GAFFNEY BOARD OF PUBLIC WORKS

I-85 SEWER EXTENSION  
CONTRACT 1C – COLLECTIONS

ADDENDUM NO. 6

January 10, 2024

C-08-102A

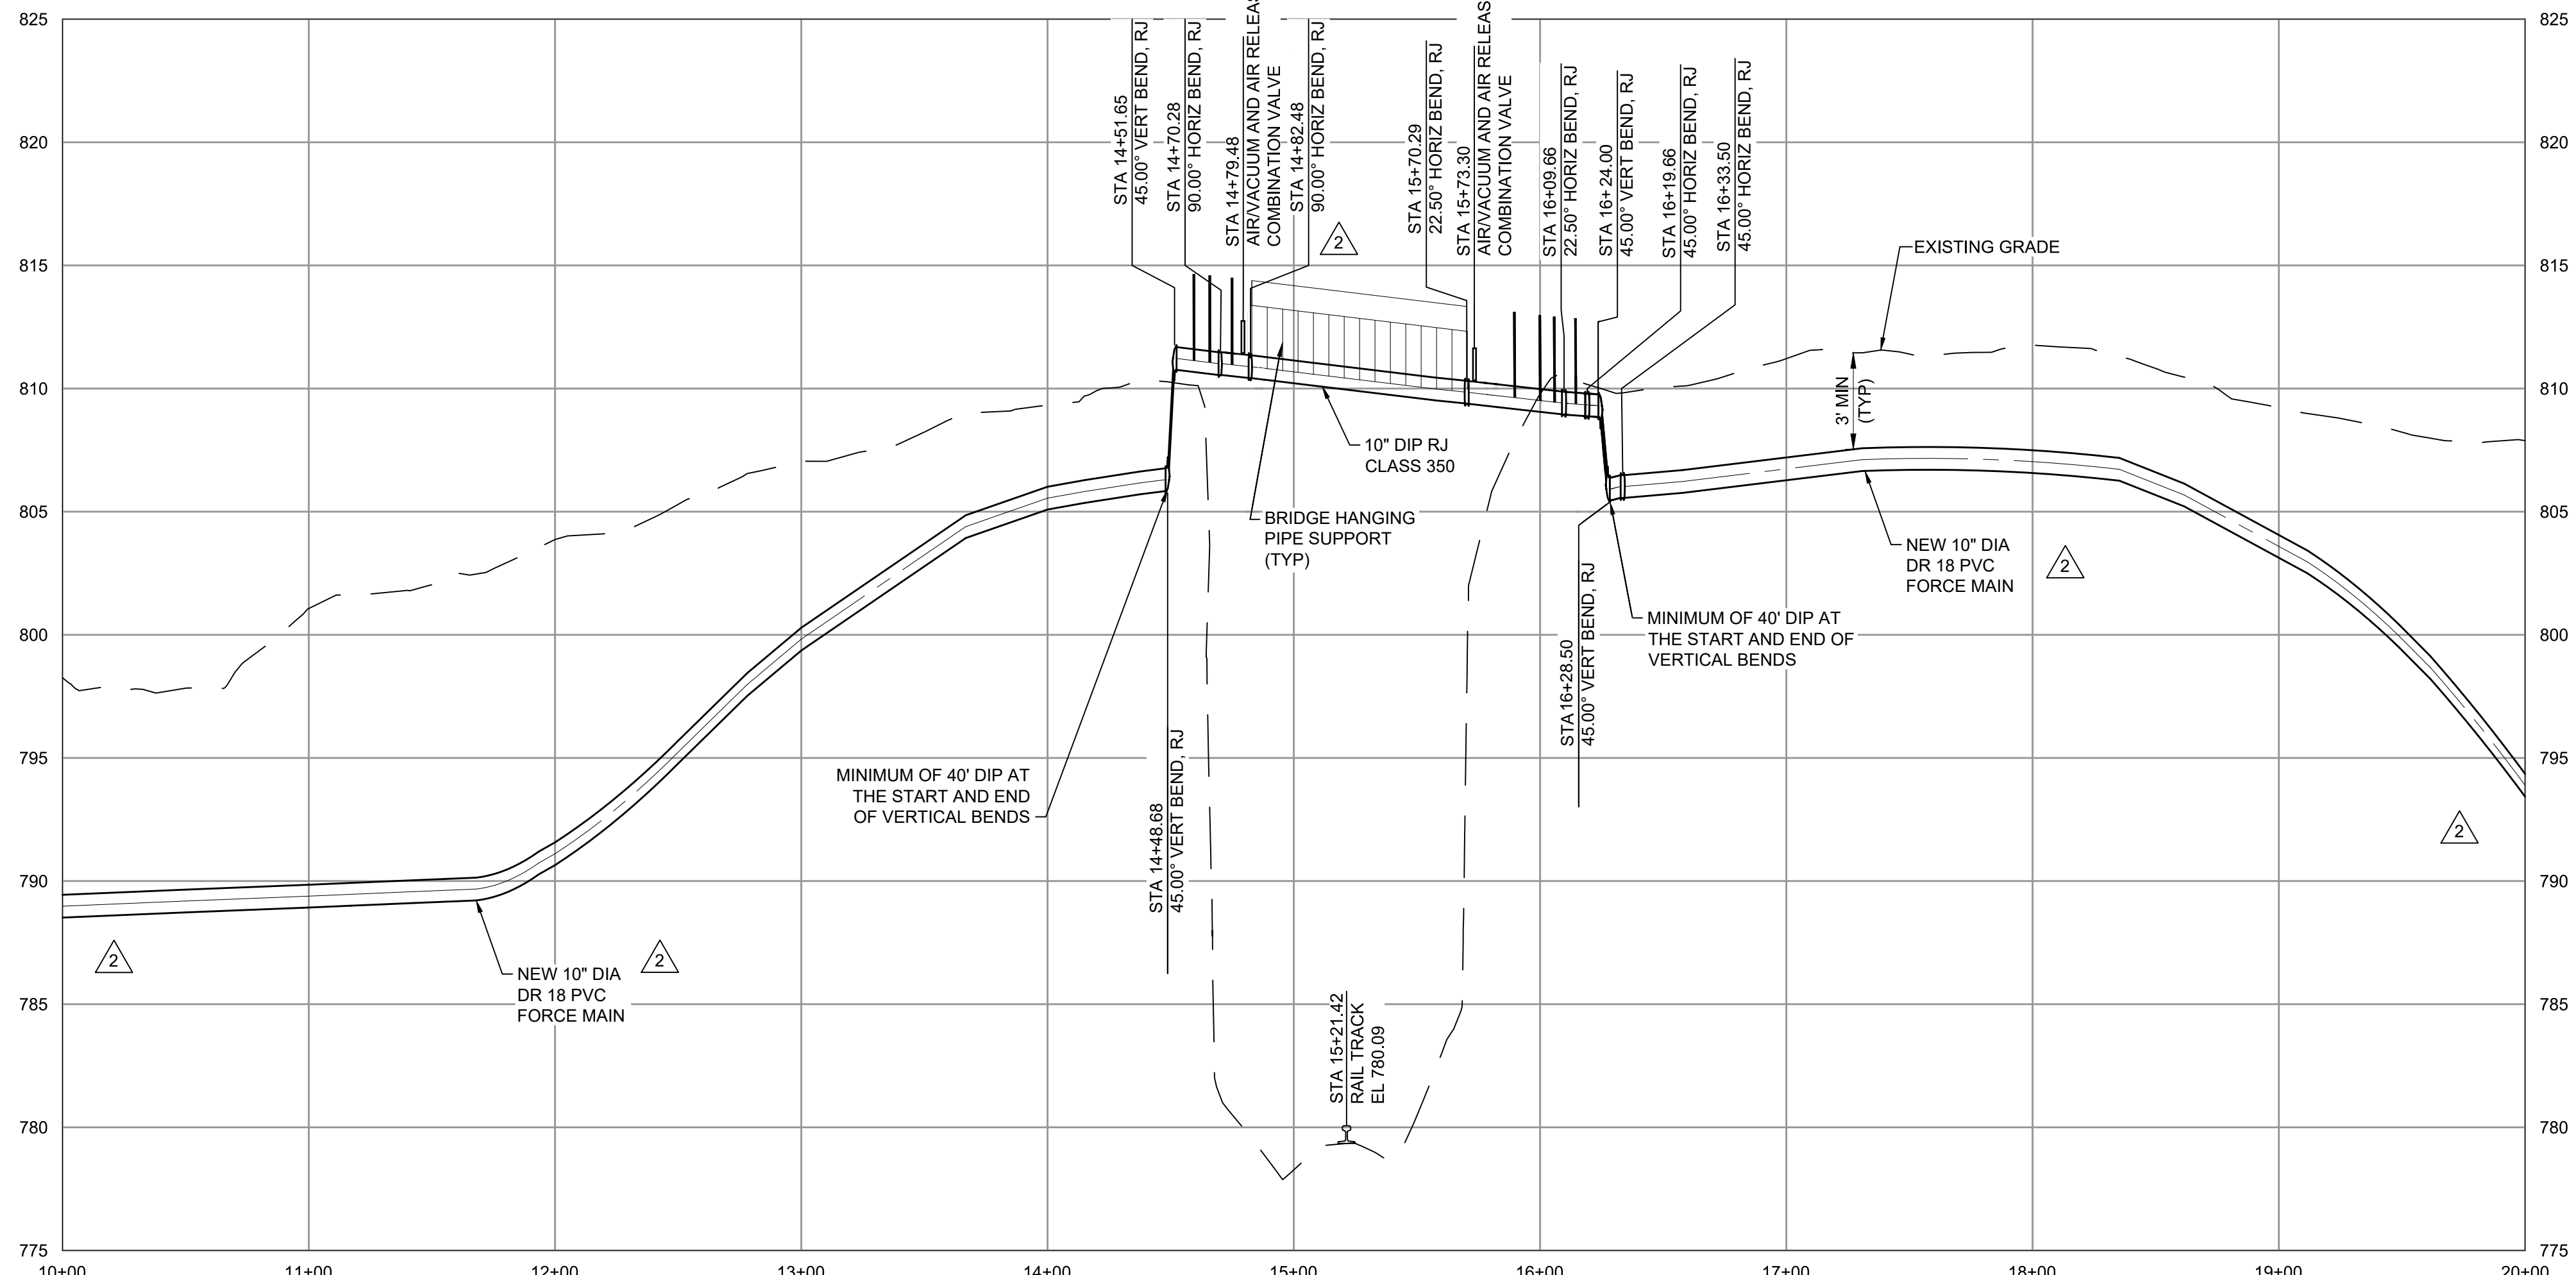
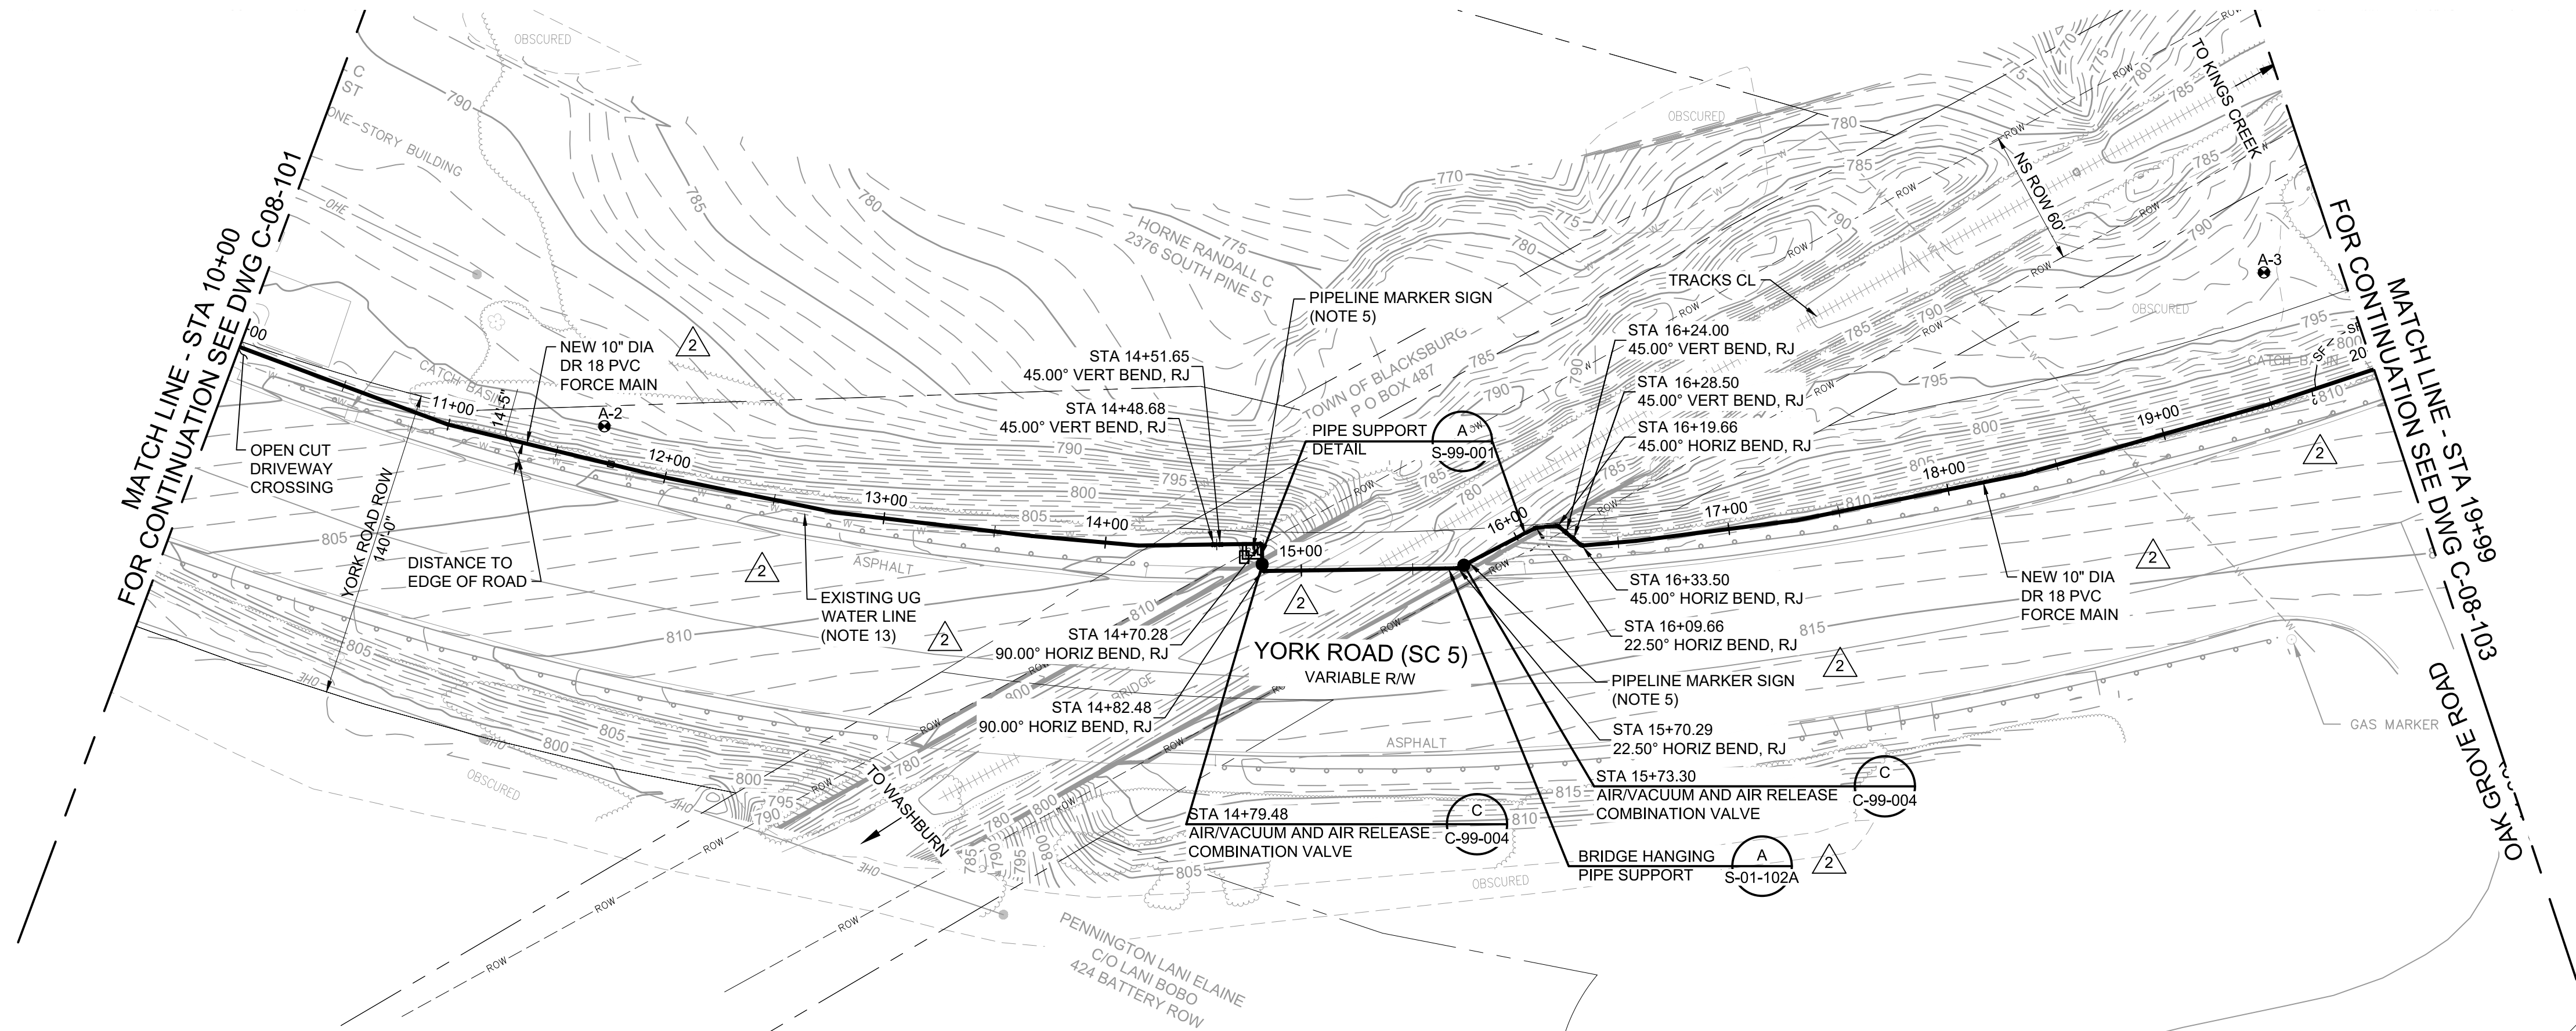
- i. Insert the attached new sheets C-06-103A and C-06-104A for Segment 6 Alternative 1 and the new sheet C-08-102A for Segment 8 Alternative 2 after sheet C-16-109.
- ii. Insert the attached new sheets S-00-001, S-01-101A, and S-01-102A for the Alternatives after sheet C-99-006.
